Byron Station, Units 1 and 2
Renewed Facility Operating License Nos. NPF-37 and NPF-66
NRC Docket Nos. STN 50-454 and STN 50-455

Subject: 2018 Annual Radioactive Effluent Release Report

**Byron Station
ODCM Revision 14 Change Summary Matrix**

Figure 2-1
SIMPLIFIED HVAC AND GASEOUS
EFFLUENT FLOW DIAGRAM
(SHEET 2 OF 2)
FLOWS LISTED IN CFM

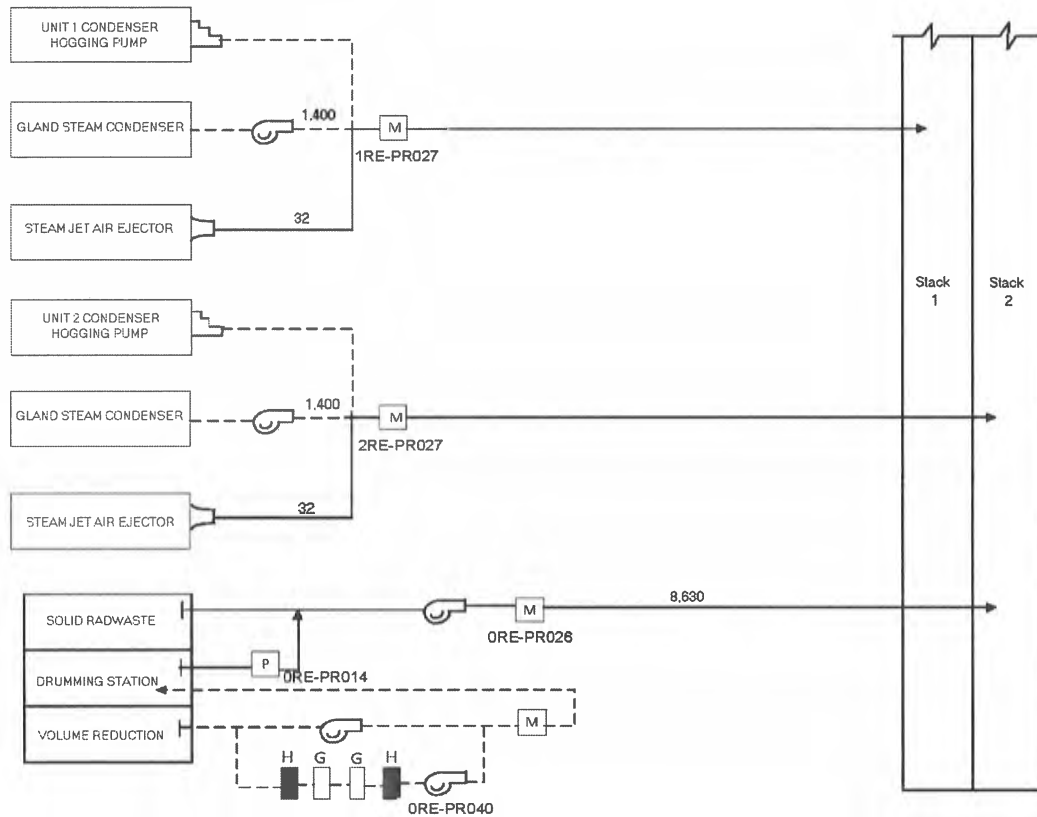
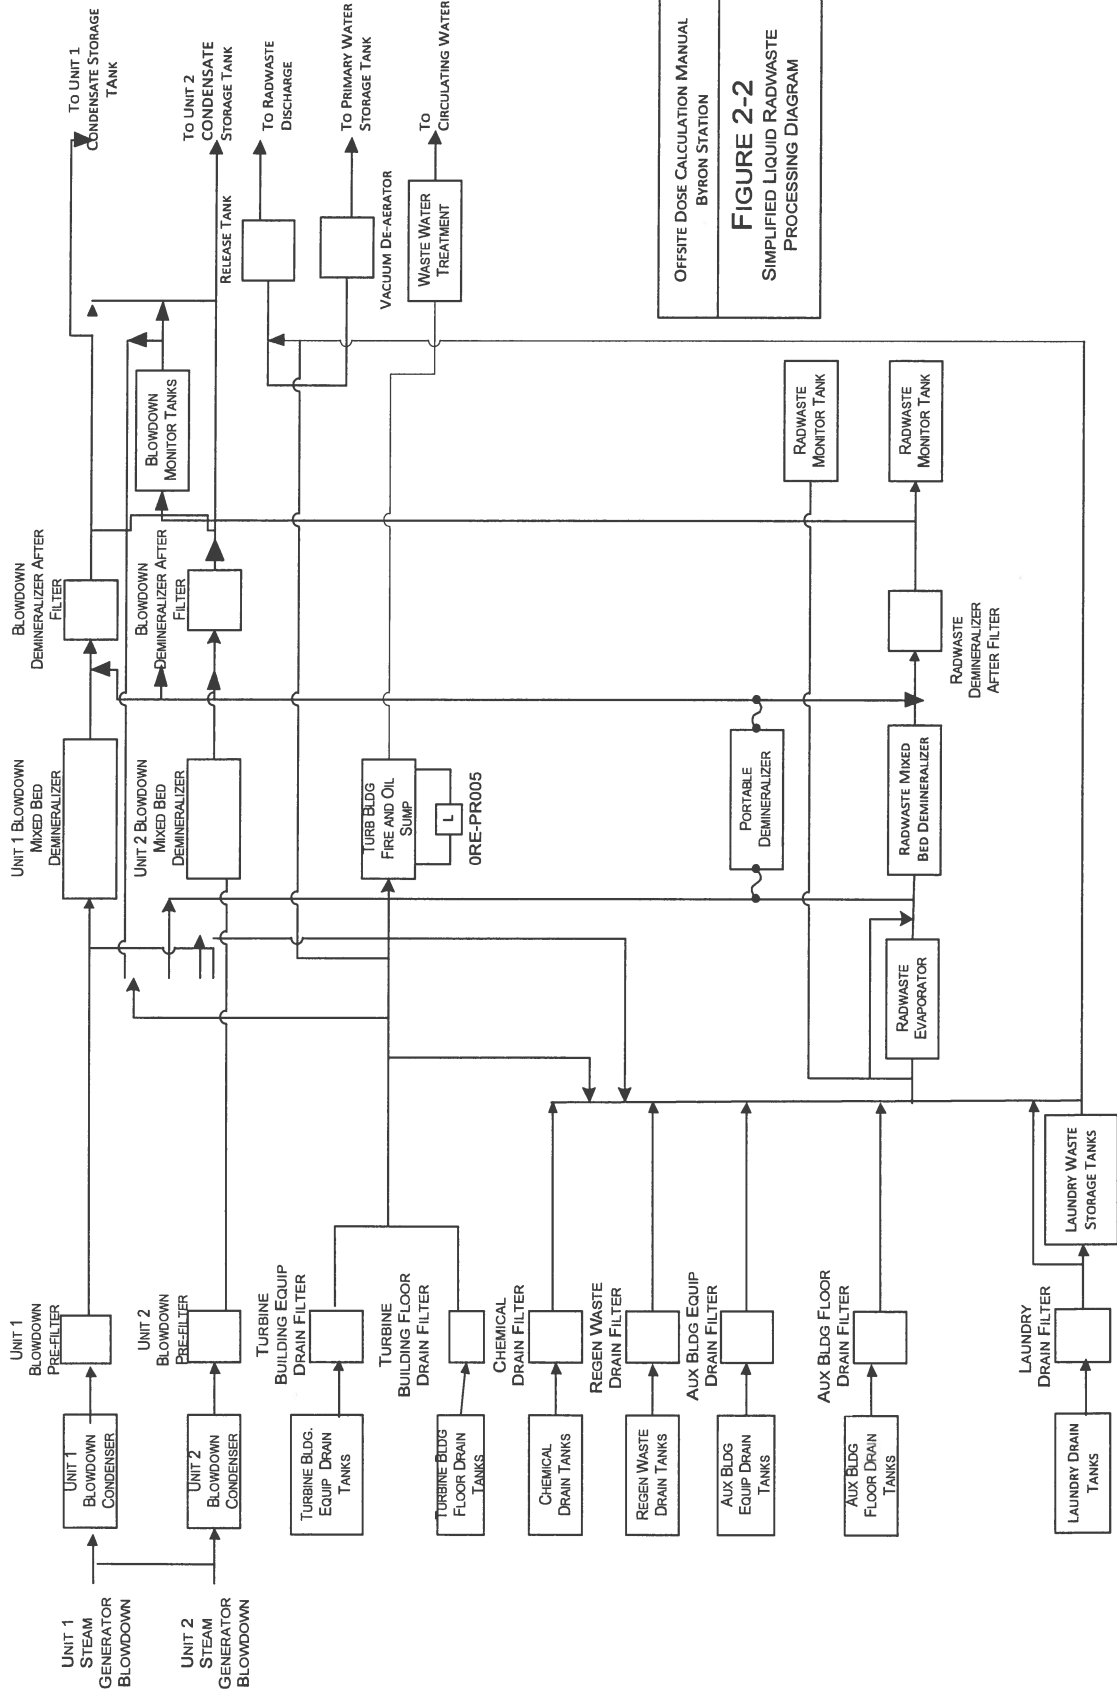
Item No.	(old) Rev. page No.	(new) Rev. page No.	Determination Identifier	Description of Change
1.	61 of 188 Figure 2-1	61 of 188 Figure 2-1	B	<ul style="list-style-type: none"> • Changed containment mini-purge flow from 4,000 to 3,000 cfm. • Changed Post-LOCA purge flow from 440 to 400 cfm • Changed Aux Bldg Access Areas flow from 125,400 to 125,460 cfm. • Changed Aux Bldg Non-Access flow from 125,400 to 125,460 cfm. • Changed Aux Bldg Plenum flows from 135,900 to 135,980 cfm. • Changed Sample Rooms & Laboratories from 13,000 to 14,430 cfm.

2.	61 of 188 Figure 2-1	61 of 188 Figure 2-1	A	Added "Flows listed in cfm" to Figure 2-1 description
3.	62 of 188 Figure 2-1	62 of 188 Figure 2-1	B	<ul style="list-style-type: none"> • Removed U1 & U2 Condenser Hogging Pump flows during startup (2,500 cfm). • Removed U1 & U2 Gland Steam Condenser Normal flow (1,432 cfm). • Added Solid Radwaste flow (8,630 cfm). • Removed Drumming Station flow (3,100 cfm). • Removed F (Refueling Operation) from legend key and from Unit 1&2 Condenser Hogging Pump flow paths. • Removed N (Normal Operation) from legend key and from Unit 1&2 Condenser Hogging Pump flow paths.

4.	62 of 188 Figure 2-1	62 of 188 Figure 2-1	A	Added "Flows listed in cfm" to Figure 2-1 description
5.	62 of 188 Figure 2-1	62 of 188 Figure 2-1	C	<ul style="list-style-type: none"> • Removed Offgas Filter Unit as a result of Engineering Calc BYR16-012 and EC 402668. • Removed NOTE 3 (Filter unit operates only when high radiation is detected in offgas system effluent discharge).

Based on a thorough review of the UFSAR, some flows listed in Figure 2-1 were either inconsistent, incorrect, or not found in the UFSAR. Therefore, Figure 2-1 is was updated for the purpose of aligning the flow parameters with those listed in the UFSAR. The update to the figure did not affect the way doses are calculated. Most of the flow rates listed in Figure 2-1 are not used in effluent calculations. Current procedural requirements either use flow rates that are consistent with or conservative with respect to the flow rates listed in the UFSAR. Therefore, the changes to Figure 2-1 had no impact on plant effluents, radioactive controls, or dose calculations.
